DISTRICT COUNCIL OF ROBE ASSESSMENT PANEL

DEVELOPMENT NO.:	22000433
APPLICANT:	Matthew Somers
ADDRESS:	2B DAWSON DRIVE, ROBE
NATURE OF DEVELOPMENT:	Two-storey Detached Dwelling with Roof Deck and Carport
ZONING INFORMATION:	Zone: Neighbourhood Overlays: Affordable Housing Hazards (Bushfire - Urban Interface) Hazards (Flooding - Evidence Required) Native Vegetation Prescribed Wells Area Water Protection Area Water Resources Technical Numeric Variations (TNVs): Minimum Frontage Minimum Site Area Maximum Building Height (Levels)
LODGEMENT DATE:	14 Jan 2022
RELEVANT AUTHORITY:	Assessment panel at District Council of Robe
PLANNING & DESIGN CODE VERSION:	2021.17 - 16 December 2021
CATEGORY OF DEVELOPMENT:	Code Assessed - Performance Assessed
NOTIFICATION:	Yes
RECOMMENDING OFFICER:	John Mason Consultant Planner
REFERRALS STATUTORY:	Nil
REFERRALS NON-STATUTORY:	Nil

PRIVACY SCREENING DETAILS

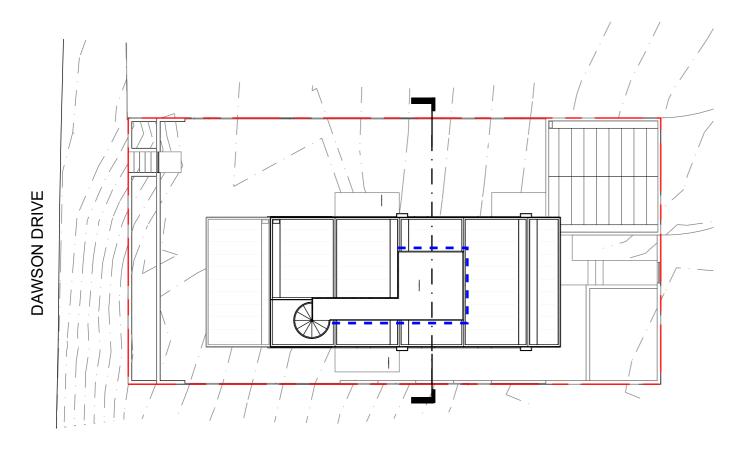
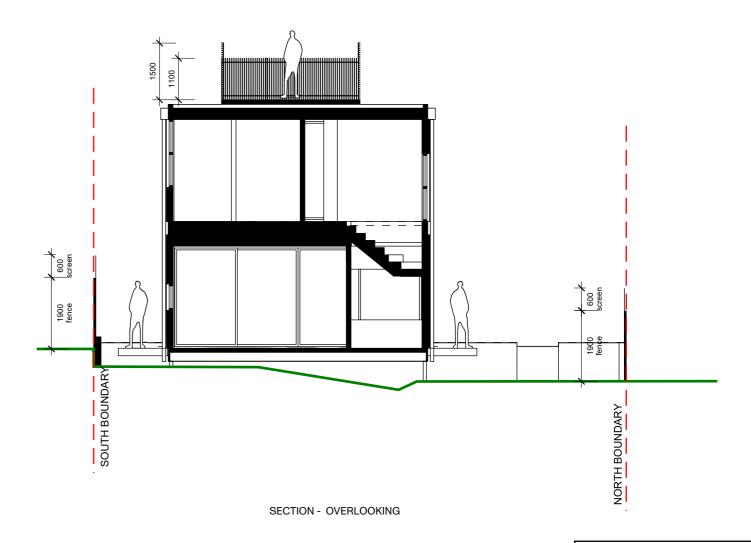
Representors Issues	Applicant Response
Overlooking from the roof top deck and appropriate	The height of the balustrading and screening has
screening measures put in place.	been raised to 1500mm and details of the screens are illustrated on the plans. The screening is considered to mitigate overlooking from the roof top deck.

The small decks on the lower level on the northern and southern sides of the dwelling would benefit from the establishment of privacy screens on them, given when persons are standing on them they will be able to see over the fence to the north and south. Therefore, it is recommended that privacy screens be required as an imposed condition on any approval to be established with a minimum height of 1500mm and this detail be provided to and supported by Council prior to development approval being granted. Without requiring these

A privacy screen to a minimum height of 1500mm be added to the northern and southern lower level decks with details to be provided to, and supported by, Council prior to development approval being granted.

Response: please find attached amended plans for the roof deck balustrading.

The height of the balustrading has been increased to 1500 mm on the northern, eastern & southern sides of the roof deck and to 1100 mm on the western side (where there is no overlooking or potential overlooking). The details of the proposed privacy screening (Louvreclad Mirage Series MSS MSS-40360/135-60 or similar / max. 25% opening / transparency) have also been included on the amended plans.
